Re: Proposed Development at Bicester Gateway: LLFA Response

**FLOOD RISK AND
DRAINAGE ASSESSMENT
FOR A PROPOSED
COMMERCIAL
DEVELOPMENT ON LAND
TO THE WEST OF
WENDLEBURY ROAD,
BICESTER, OXFORDSHIRE**

**PROJECT NO.
JAG/AD/JP/43386-Rp001D**

9.0 **RESPONSE TO LLFA QUERIES**

Figure 4: Environment Agency Map dated December 2019
Showing the Extent of Flooding from Surface Water

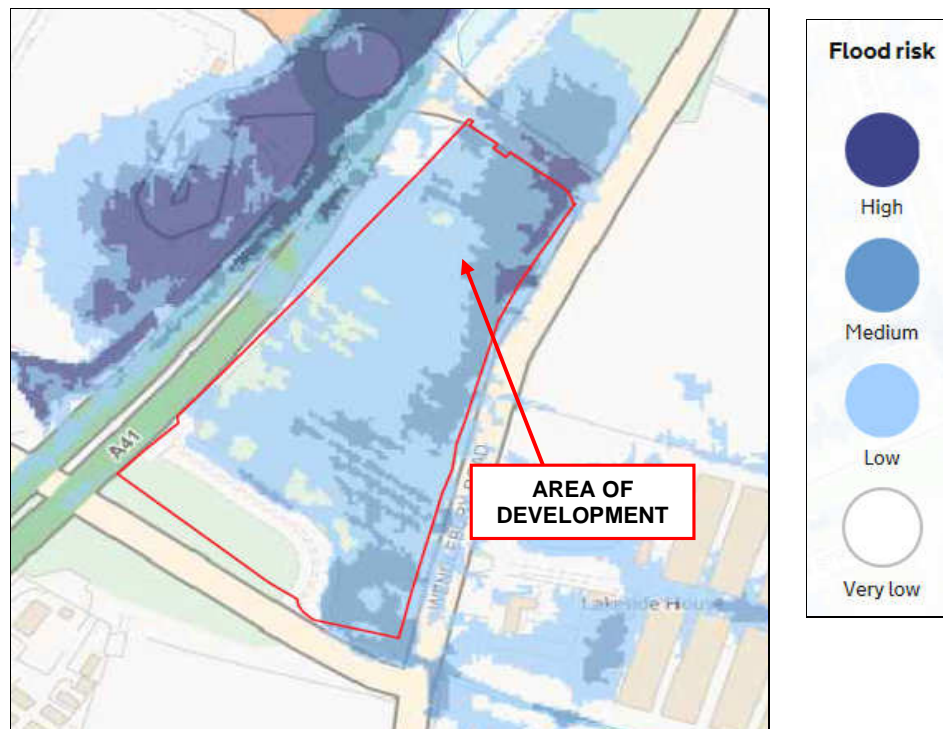
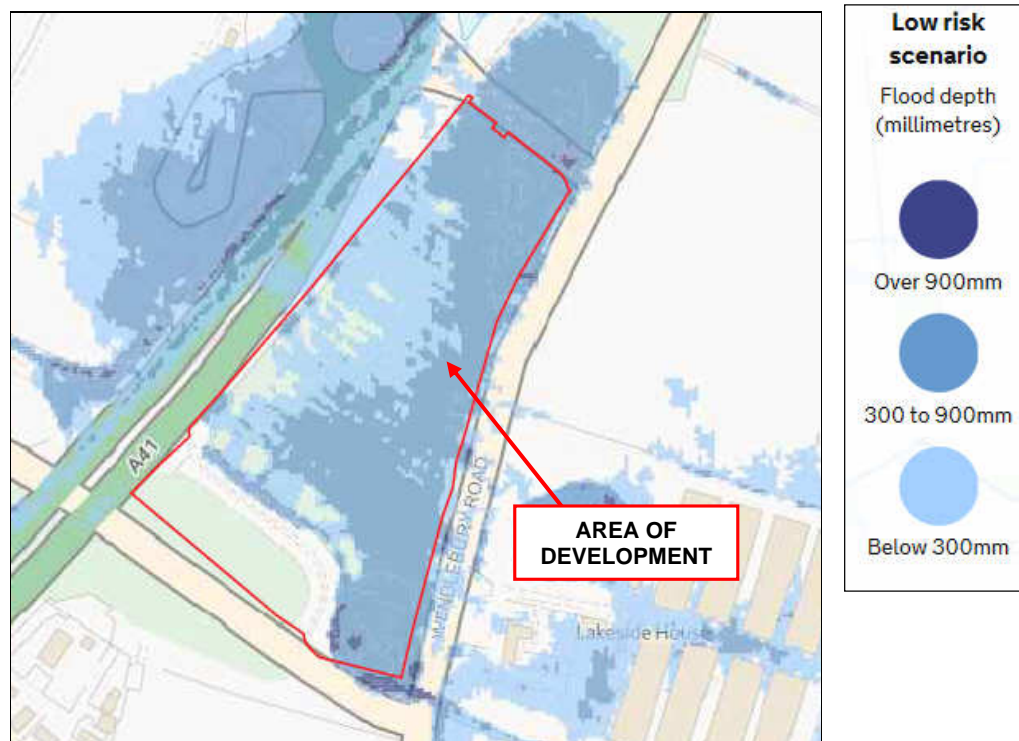
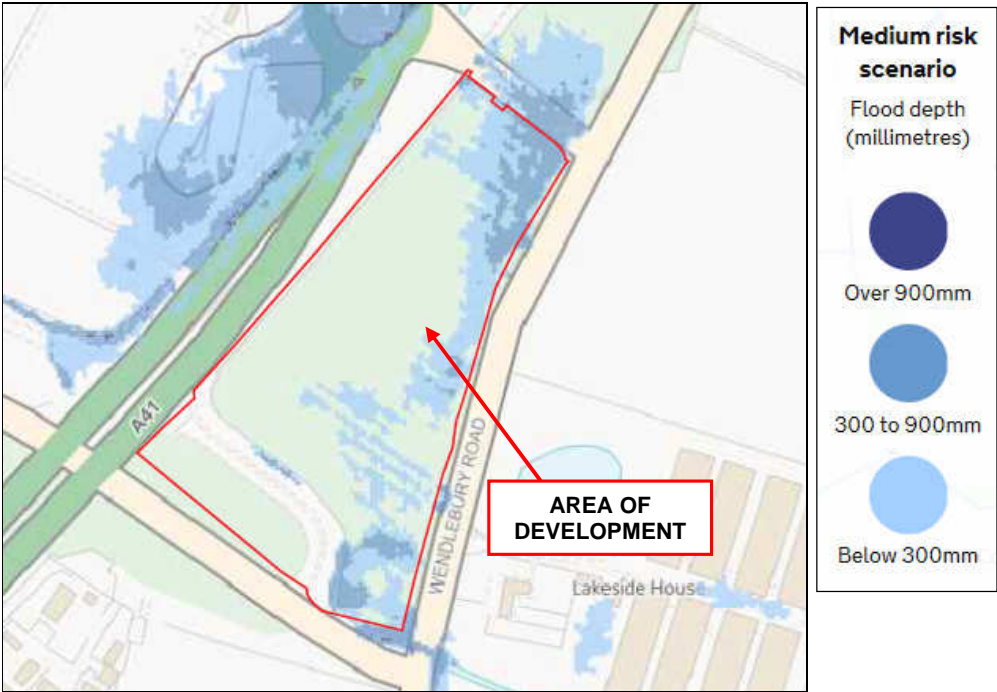
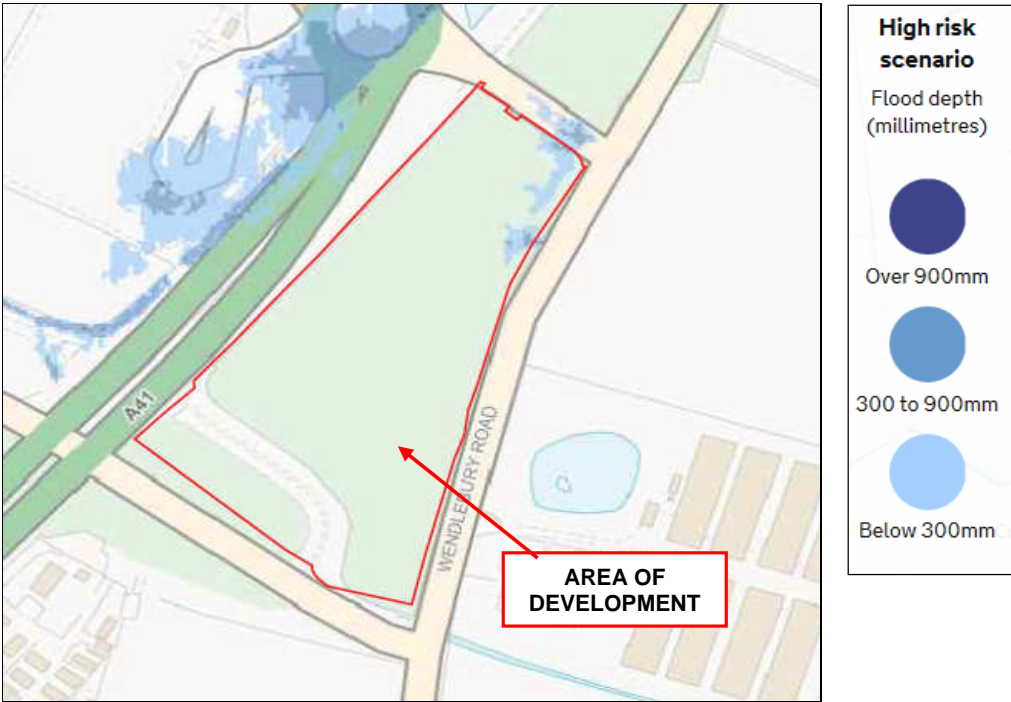
In relation to surface water flood risk the site is shown to be theoretically at risk from flooding up to 900mm, even though it is in Flood Zone 1 (less than 1 in 1000 annual probability of flooding in any year).

The flood depths on the surface water mapping are based on a simple assessment, using the site's topography and assumes no drainage is in place. In reality the drainage ditches provide a mechanism for collection, conveyance and capacity, and these currently manage the surface water on site, and there have been no known instances of the site flooding.

Furthermore, the site will have a SuDS system which controls flows to an agreed rate, and excess flows will be balanced up to the 1 in 100 year, plus climate change, allowance, which is an improvement to the current situation, therefore the overall risk from surface water flooding is considered to be low.

However, taking the theoretical flood depth at its highest, the flood level could be 64.90mAOD, based on the ditch invert level of 64mAOD.

The finished floor levels of the proposed buildings will be set at 65.30mAOD, which is above the theoretical flood depth, with 400mm freeboard.
